STATE OF NORTH CAROLINA
DEPARTMENT OF TRANSPORTATION

Subject: **Revised Application for a Section 404 Individual Permit, Section 401 Water Quality Certification, and Neuse Riparian Buffer Authorization** for construction of the widening of NC 42 from US 70 (Clayton) to east of SR 1902 (Rocky Branch Rd) in Johnston County. Federal Aid Project No. STP-42(4). State Project No. 8.1312301. TIP No. R-3825A.

Please find revised permit drawings and roadway plans showing the reduction in wetland impacts from the previously submitted drawings. In addition, a revised Debit Ledger for the Marks Creek Mitigation Site reflecting the wetland impact reduction is also included.

Revised Permit Drawing
11/14/11 Sheet 2 of 13

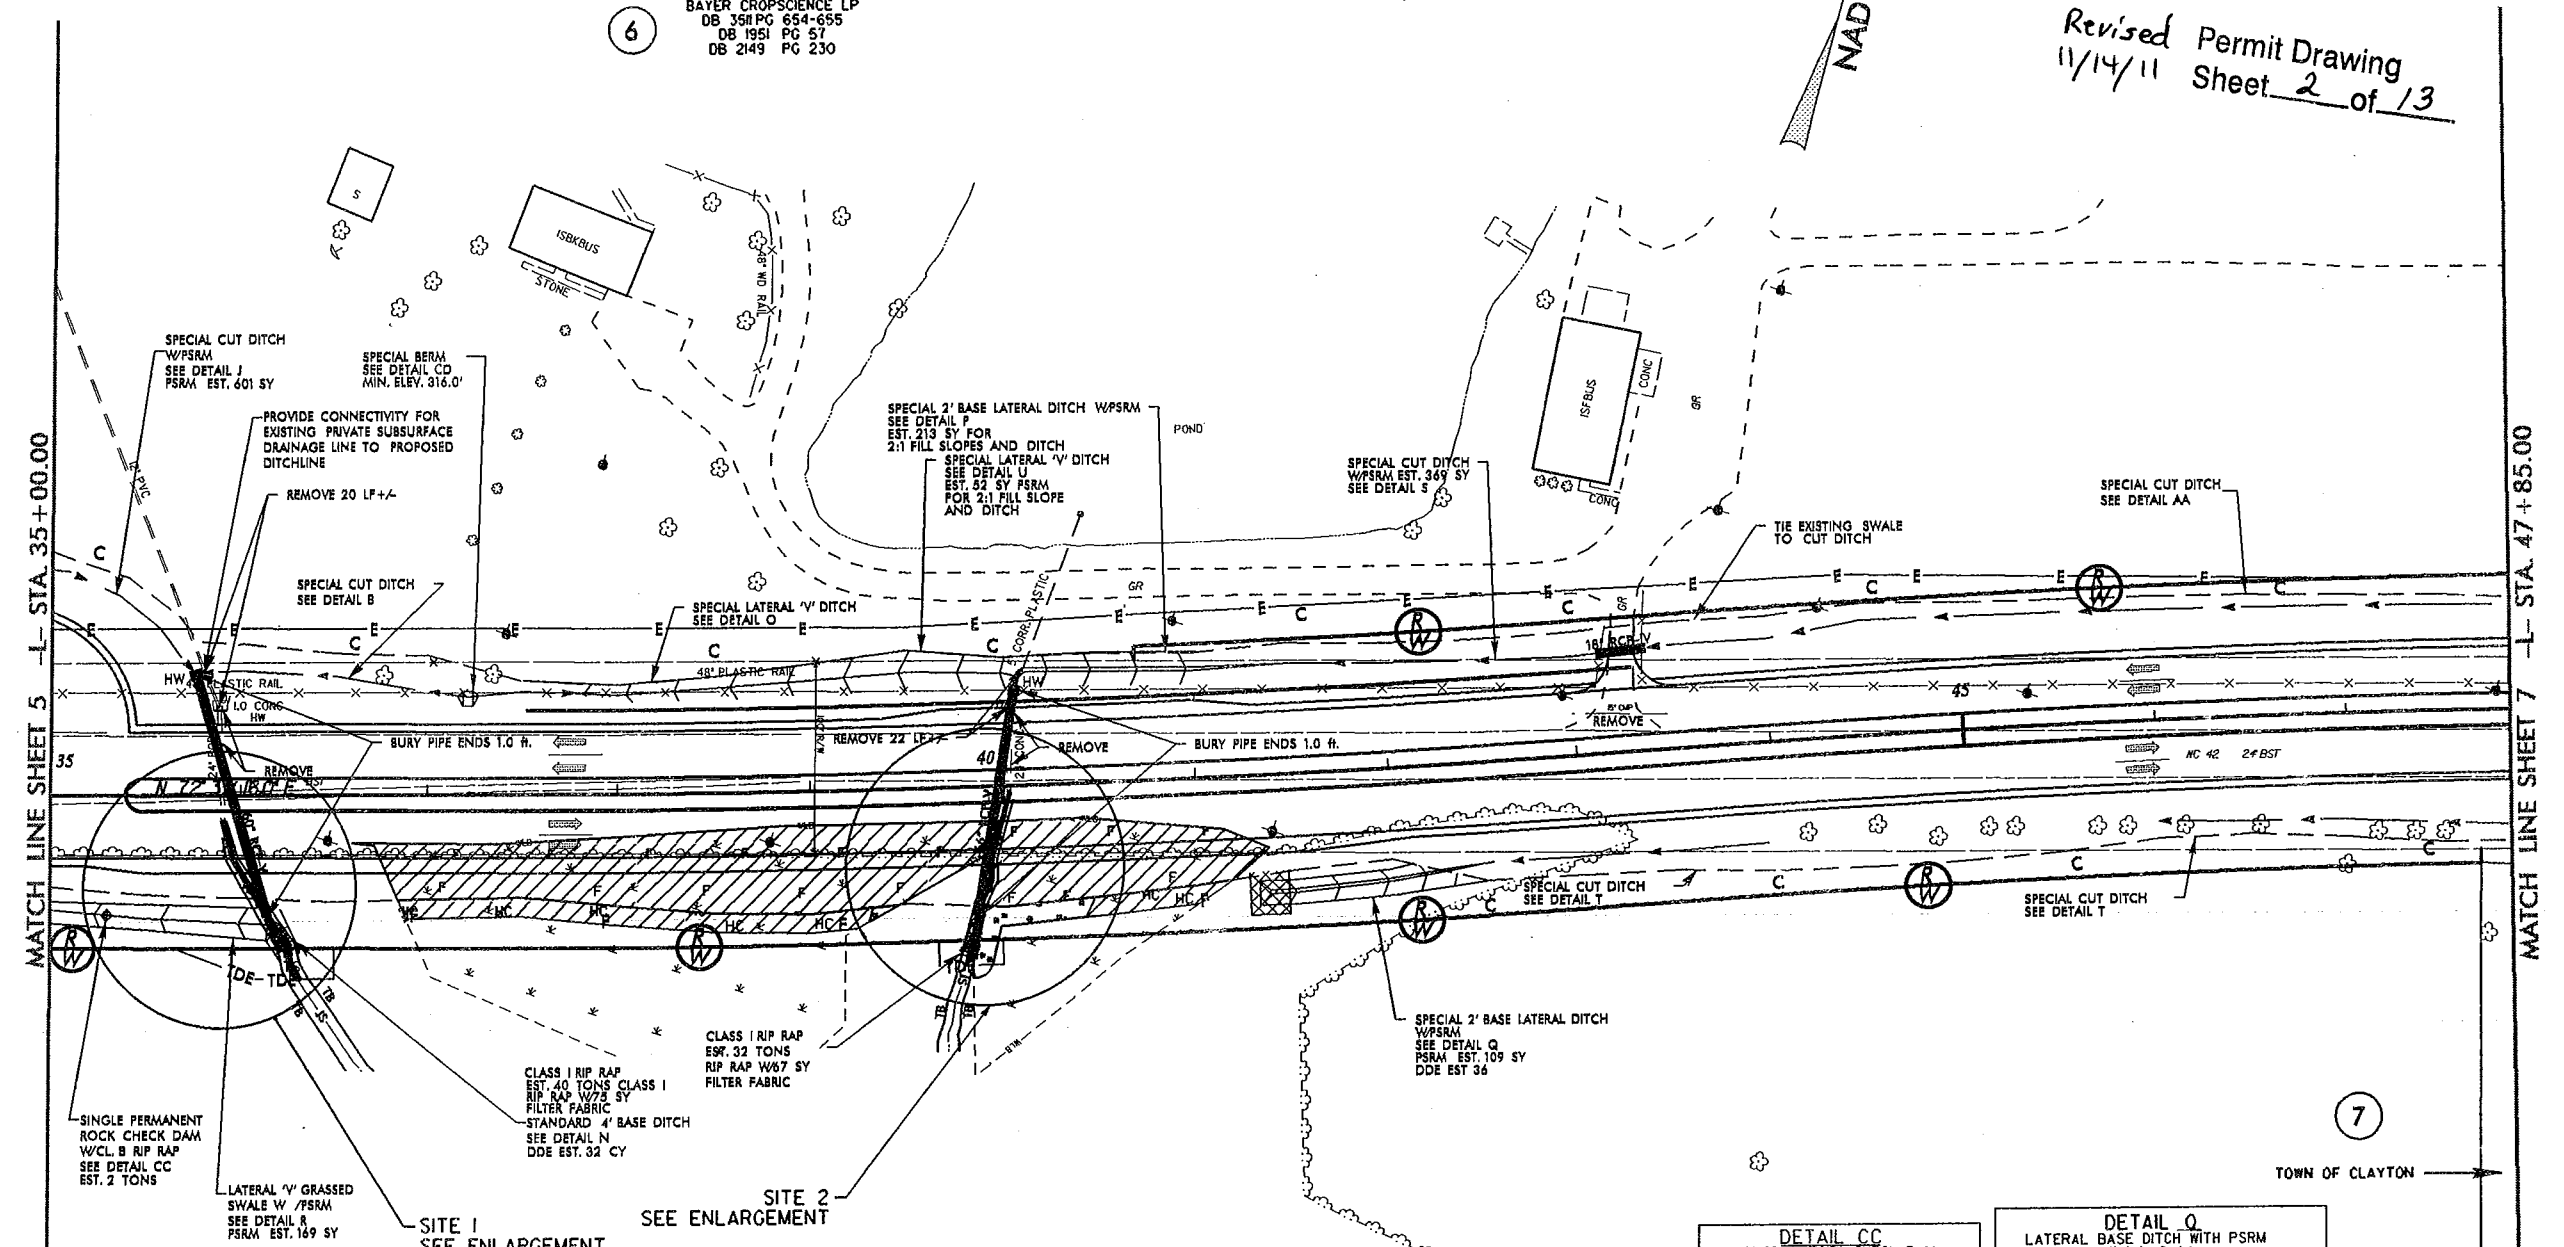
Permit drawing sheets 2 of 13, 5 of 13, and 13 of 13 were changed as follows:

Site 2 - Revised due to the change from mechanized clearing to hand clearing. Thus, the summary sheet changed from 0.13 acre of mechanized clearing to 0.06 acre, and from no hand clearing to 0.07 acre. Temporary fill due to erosion control devices will be 0.01 ac.

PROJECT REFERENCE NO. R-3825A	SHEET NO. 7
RW SHEET NO.	
ROADWAY DESIGN ENGINEER	HYDRAULICS ENGINEER
PRELIMINARY PLANS DO NOT USE FOR CONSTRUCTION

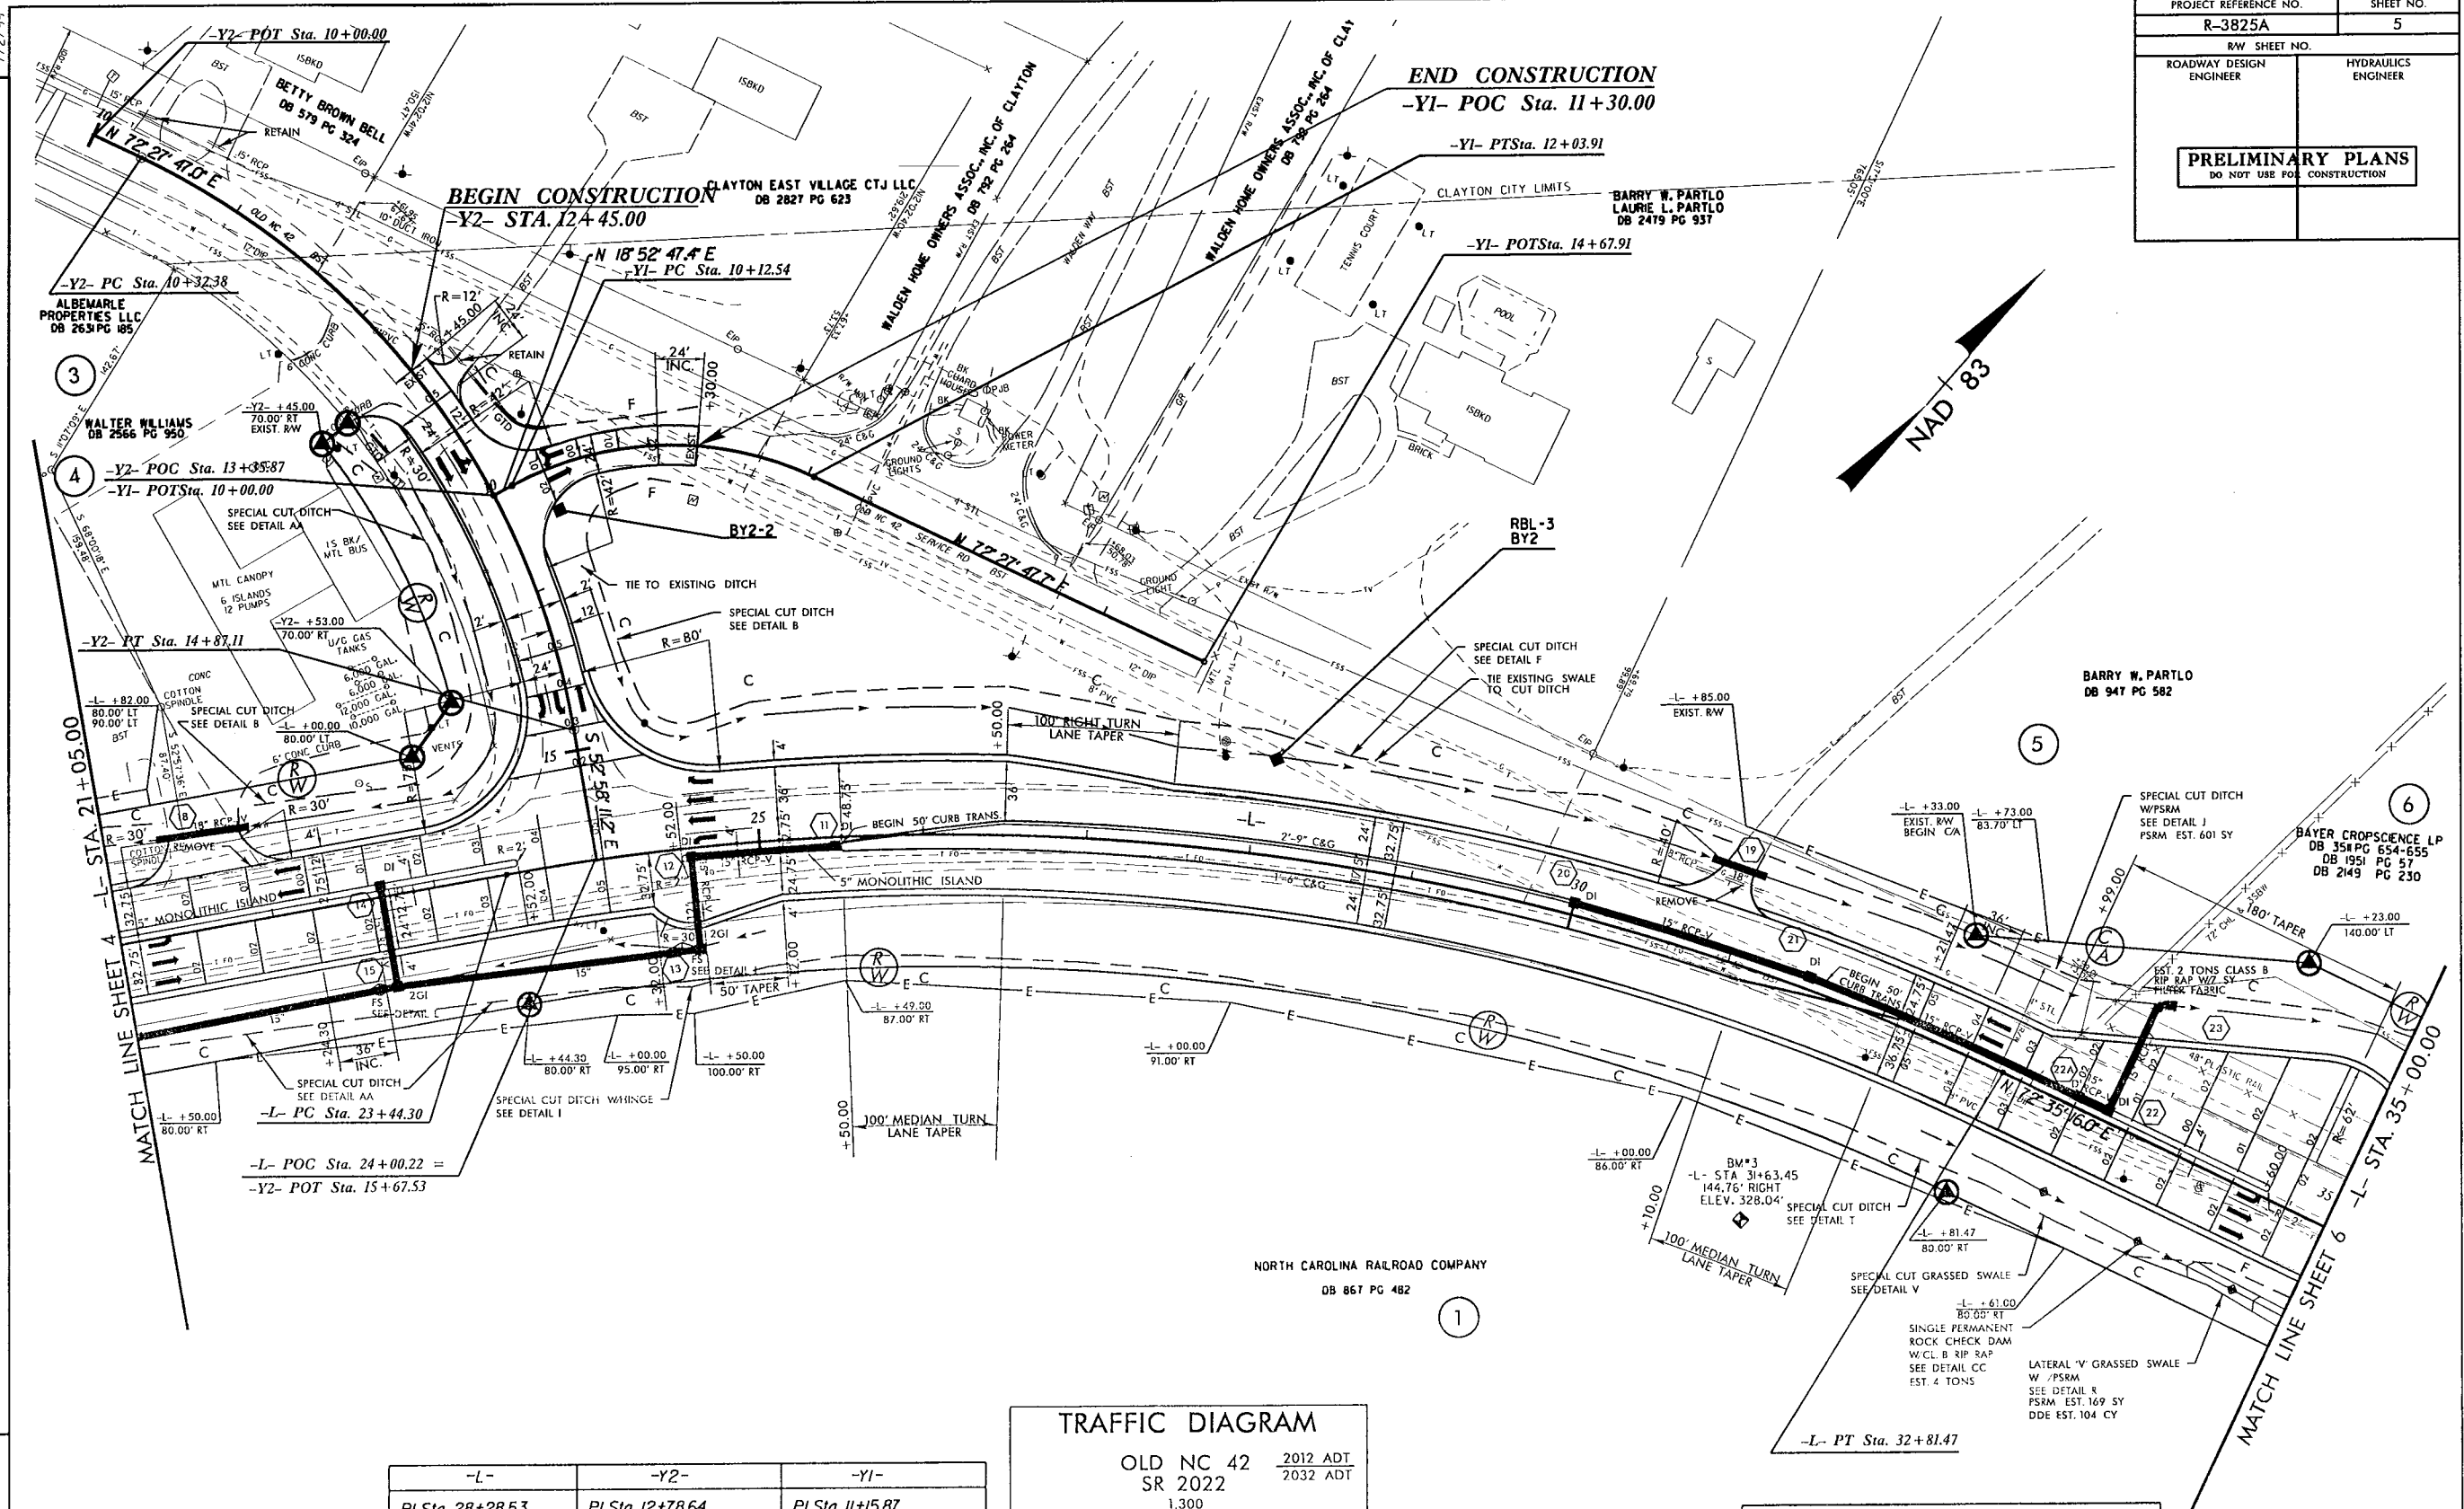
Roadway plan sheets 5, 7, 8, and 9 were changed as follows:

(Sheet 5) -Revising property owner name from Benjamin A. Orringer to Barry W. Partlo.

REVISIONS
 03/23/11 RW REVISIONS: ADDED A U-TURN BULB, CA AND RW AND REMOVED THE TCE ON PARCELS NO. 5 AND 6. SCL
 06/23/11 RW REVISION: REVISED U-TURN BULB, CA AND RW AND TCE ON PARCELS NO. 5 AND 6. SCL
 11/21/11 RW REVISION: PROPERTY OWNER NAME CHANGE FROM BENJAMIN A ORRINGER TO BARRY PARTLO. SCL

PROJECT REFERENCE NO.	SHEET NO.
R-3825A	8
RW SHEET NO.	
ROADWAY DESIGN ENGINEER	HYDRAULICS ENGINEER
PRELIMINARY PLANS	
DO NOT USE FOR CONSTRUCTION

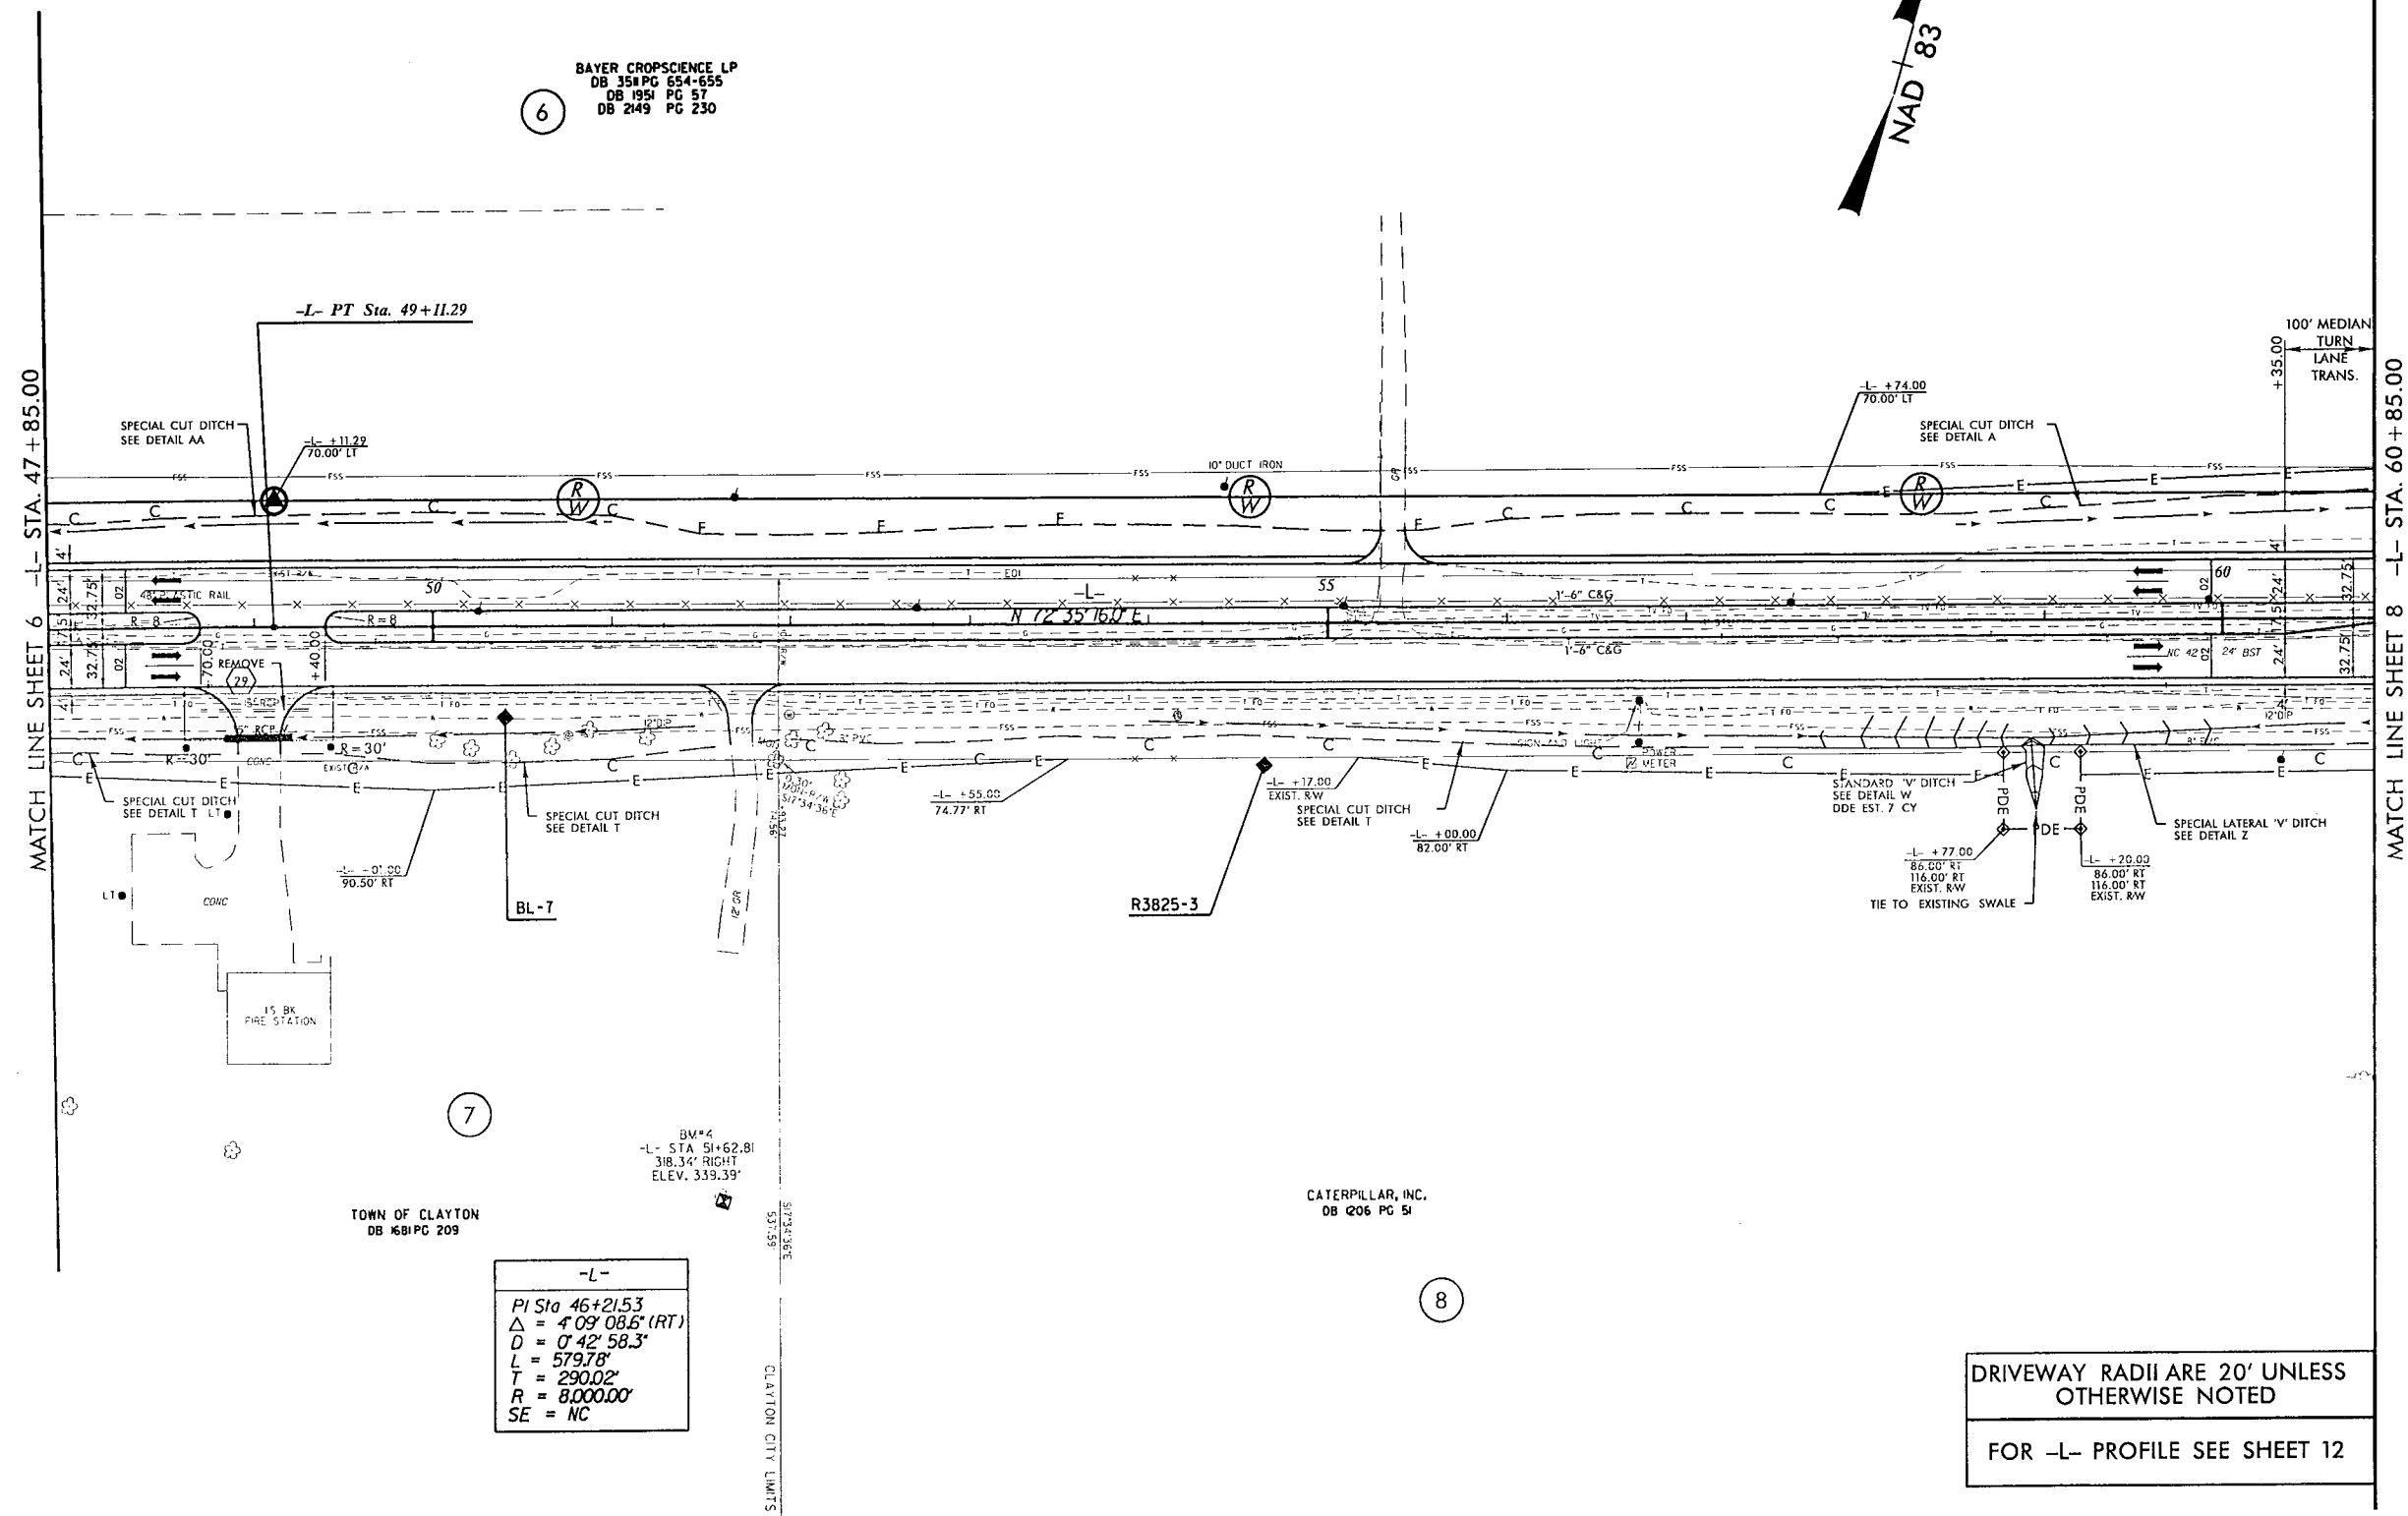
- (Sheet 7) -Revising Temporary Construction Easement to Permanent Drainage Easement around ditch on Parcel No. 8.
- (Sheet 8) -Revising Temporary Drainage Easement to Permanent Drainage Easement around ditch on Parcel No. 10.
-Modifying Temporary Construction Easement on Parcel No. 9.
- (Sheet 9) -Adding Permanent Drainage Easement around pipe outlet on Parcel No. 9.
-Removing a property line and eliminating Parcel No. 15.
-Revising Parcel No. 10 to Parcel No. 10A from station 76+78.74 to station 80+14.22.
-Modifying Temporary Construction Easement on Parcel No. 10A.

REVISIONS
11/2/01 RW REVISION: REVISED TCE TO PDE AROUND DITCH ON PARCEL NO. 8. DDK
